Docket No. 50-271

ORDER FOR MODIFICATION OF LICENSE

SAFETY EVALUATION OF MECHANICAL PLUGS TO BE INSERTED INTO THE BYPASS

HOLES OF THE VERMONT YANKEE NUCLEAR POWER PLANT

Figure 1. Plug Installed in Core Plate

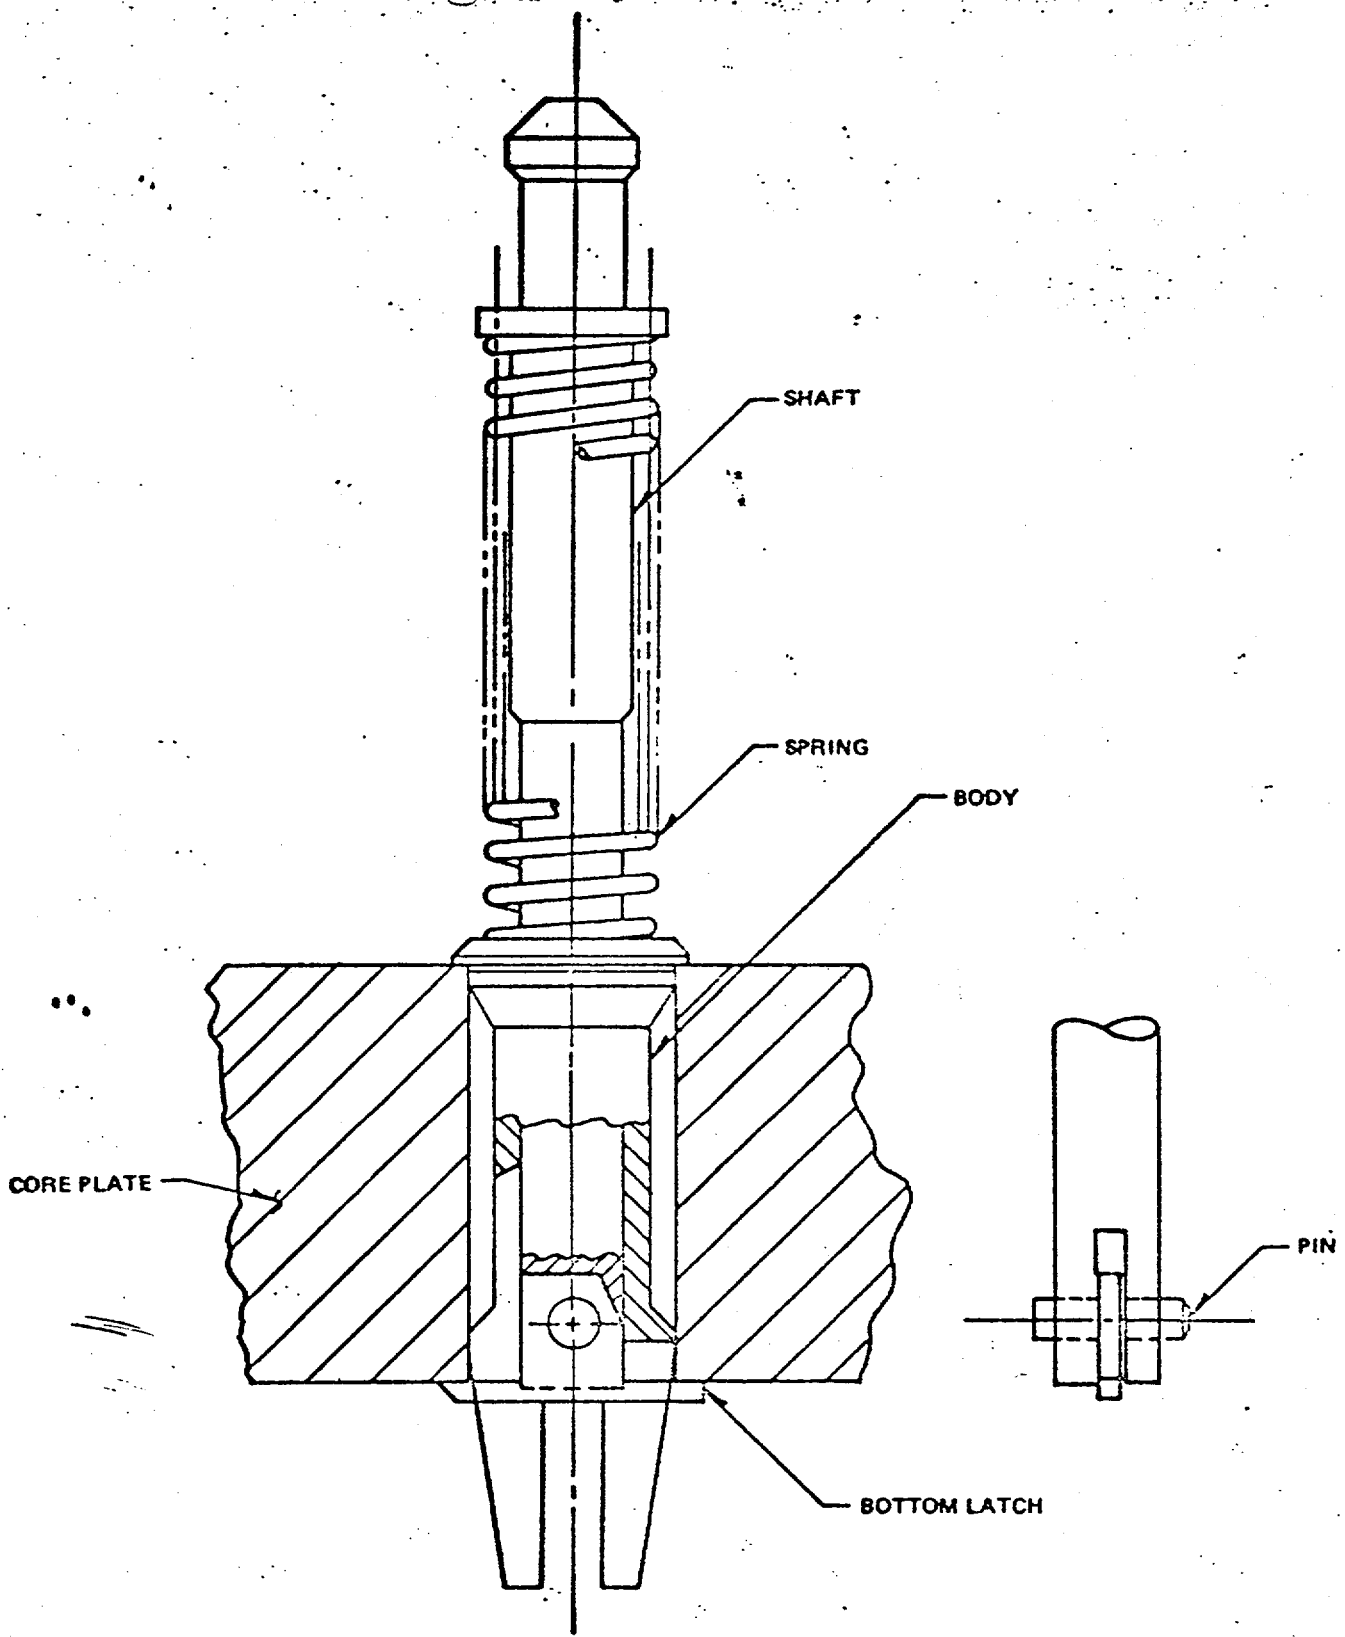
The plug consists of five basic parts, as shown in Figure 1. Identical plugs have previously been installed at Vermont Yankee, Pilgrim, and Duane Arnold. The body provides a means of guiding the device into the bypass flow holes as well as a shoulder to support the plug and form a seal against water flow. The shaft extends through the body. A knob is provided at the top of the shaft to provide a means of grabbing the plug during installation and extraction. At the bottom, the latch is attached to the shaft by a pin. The latch is free to rotate during installation. The spring acts against the body and shaft during normal operation to provide the force necessary to offset the pressure differential acting on the body.

During installation, the plug has its latch rotated 90 degrees from its installed position and withdrawn and locked in the body. The shaft is gripped by the installation tool, and the plug is inserted into the bypass flow holes. The body engages the rim of the hole. The shaft is pushed to its full extension, thus lowering and unlocking the latch below the underside of the core plate. The latch then rotates 90 degrees and bears on the bottom of the core plate. After insertion, the plug is pulled with about 30-pound force to test the placement.

The plug can be removed by gripping the top of the shaft with an extracting tool and applying a force of about 500 pounds. The latch's legs will be plastically deformed and the entire plug withdrawn. The plugs previously installed at Vermont Yankee were removed with no abnormalities or loose pieces reported. The force required for removal varied from 500 to 1300 pounds

Based on a review of the design, the test rig, the installation methods and the previously successful operating experience at Vermont Yankee, Pilgrim, and Duane Arnold, we conclude that the plugs will not fail so as to result in loose parts in the core or result in unplugging of the bypass flow holes. Also, we conclude that the installed plugs will preclude unacceptable channel box damage for at least the proposed fuel cycle. Surveillance programs will be required to confirm the nature and extent of any residual tube excitation and resultant effect, if any, on core components.

Accordingly, we conclude that the installation of the plugs should be authorized. The licensee's safety analysis for operation with plugged bypass holes, submitted July 30, 1975 is still under review.
